Eastern Area Planning Committee Wednesday 5 September 2018 at 6.30pm in the Calcot Centre, Highview (off Royal Avenue), Calcot

UPDATE REPORT

Item No: (1) **Application No:** 18/01516/HOUSE **Page No.** 39-52

Site: Grimms Dyke, Aldworth

DRAWING:
Proposed Block Plan

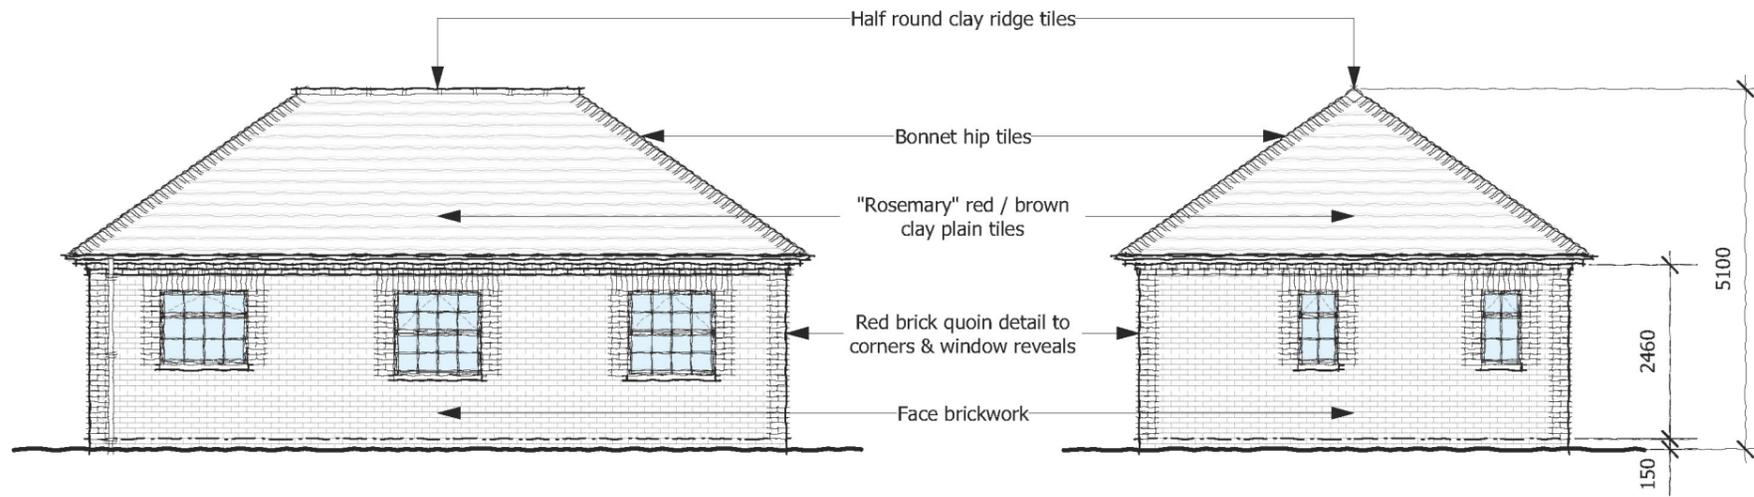
However, the proposed level of landscaping indicated on the Block Plan is considered to go beyond what is necessary to simply mitigate the impact of the proposed development, and therefore enhances the existing situation in accordance with Core Strategy Policy CS14. This in turn will help mitigate the criticised removal of mature vegetation in recent years.

The landscaping shown on the Block Plan is insufficiently detailed to secure an enforceable landscaping scheme. For this reason, condition 7 of the recommendation requires the prior approval of a detailed landscaping scheme, complete with planting schedules and detailed plans before any development takes place. Subject to this condition, it is considered that the proposed development would respect and enhance the character and appearance of the area, and incidentally help ameliorate the criticised removal of mature vegetation.
